Objection to Planning Application Reference 2017/4306/P Arthur Stanley House, 40 - 50 Tottenham Street, London, W1T 4RN (the "Planning Application")

We are instructed by BC Noho Limited (the "**Owner**") the owner of the freehold land shown edged red on the title plan (attached) known as 30 Cleveland Street (the "**Property**"). The development proposed by the Planning Application (the "**Proposed Scheme**") will have a significant adverse impact on the Property and we are instructed to submit an objection on behalf of the Owner.

Plan 3a

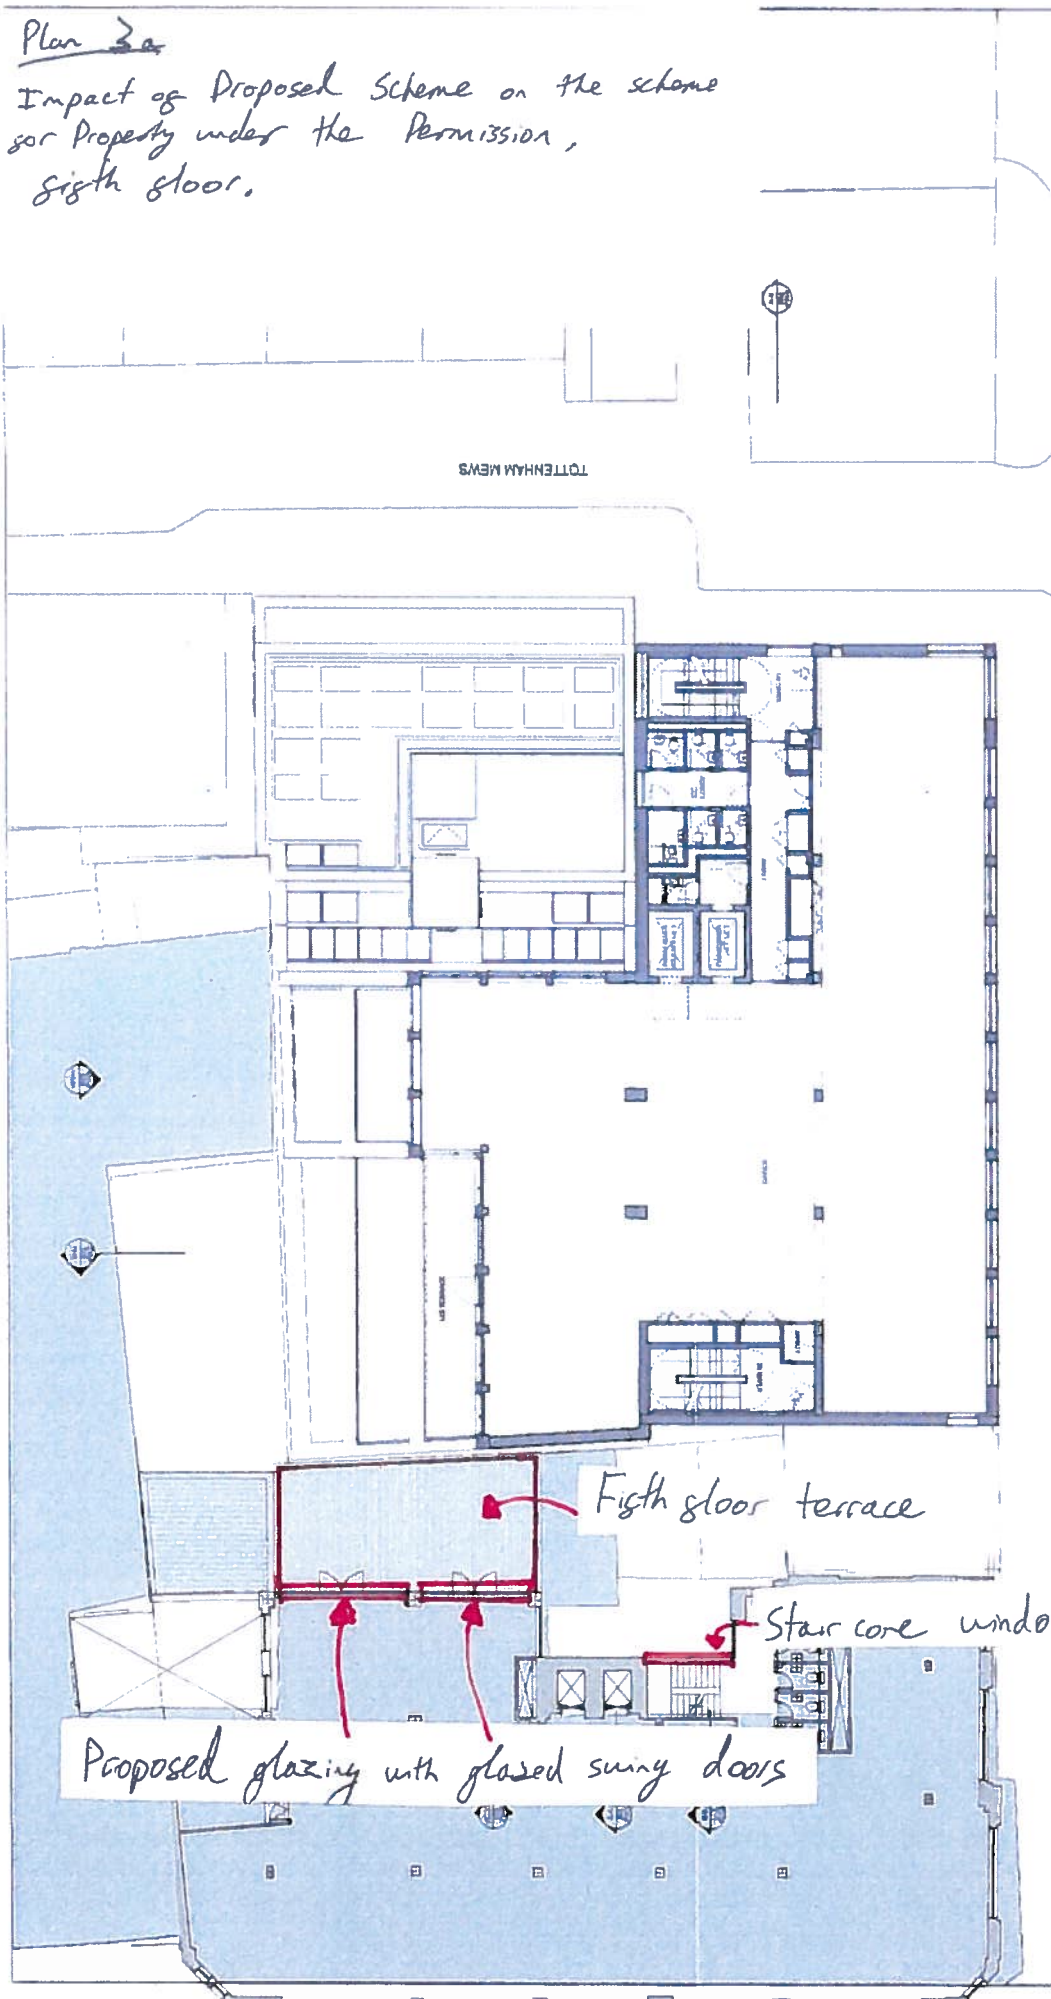
Impact of Proposed Scheme on the scheme
for Property under the Permission,
Sixth floor.

Proposed glazing with glazed sunny doors

Fifth floor terrace

Stair core window bank

Title
Existing North East Elevation

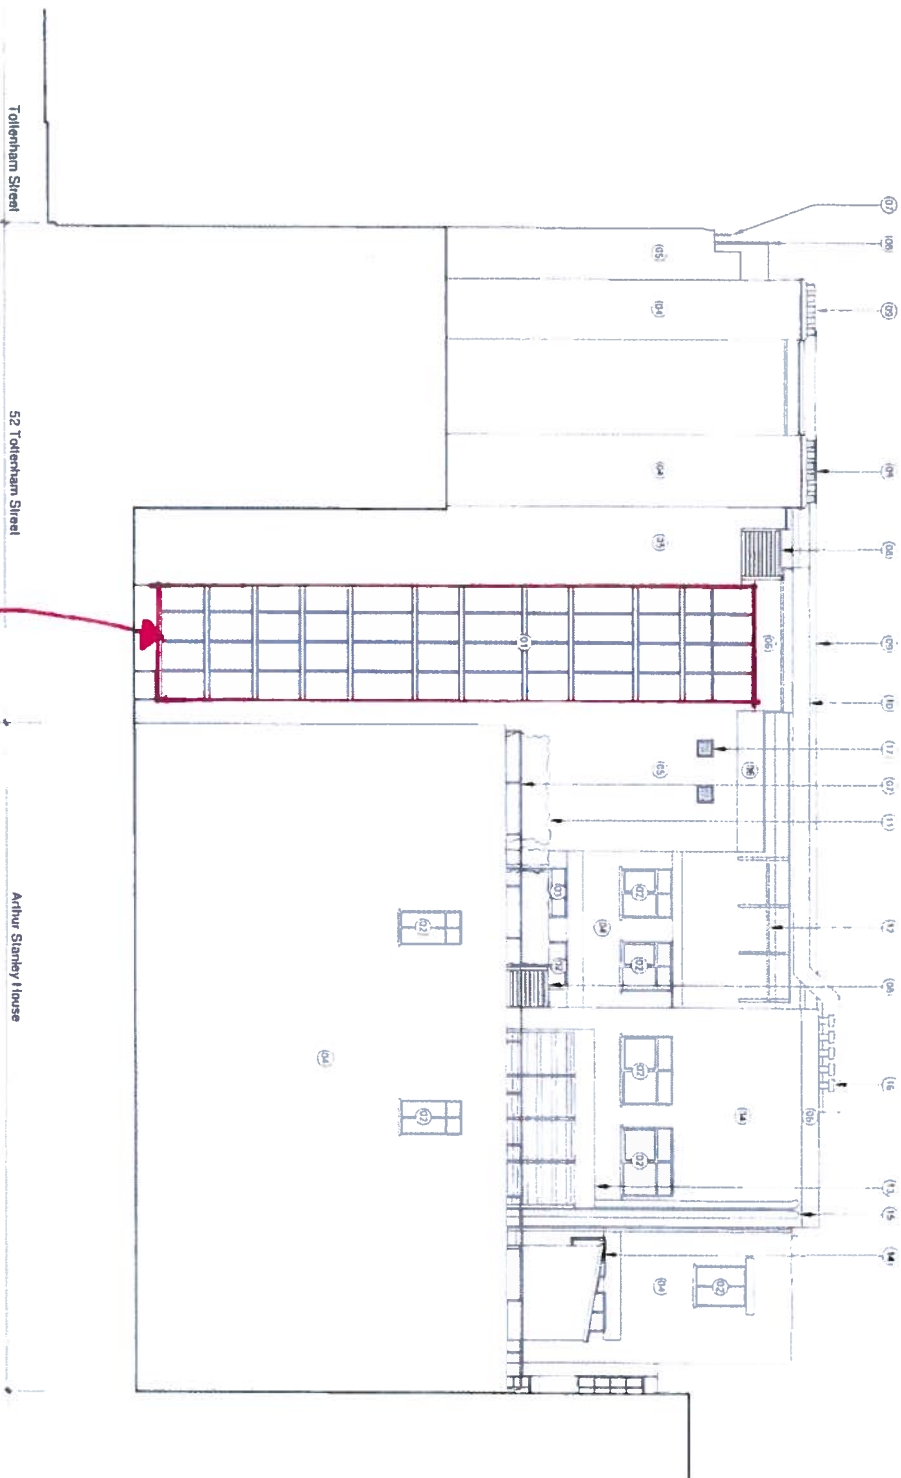
- 1.6 The bank of windows which run up the stair core at the rear of the Property will also suffer reduced light levels as a result of the Proposed Scheme. The lower levels of the stair core will likely not be lit at all if permission for the Proposed Scheme is granted. The higher levels of the stair core will suffer a material and substantial impact on light levels received as a result of the Proposed Scheme. The stair core is indicated on plan 4.

Stair core bank windows to be obstructed by Proposed Scheme. To be repaired under the scheme for the Property under the Permission.
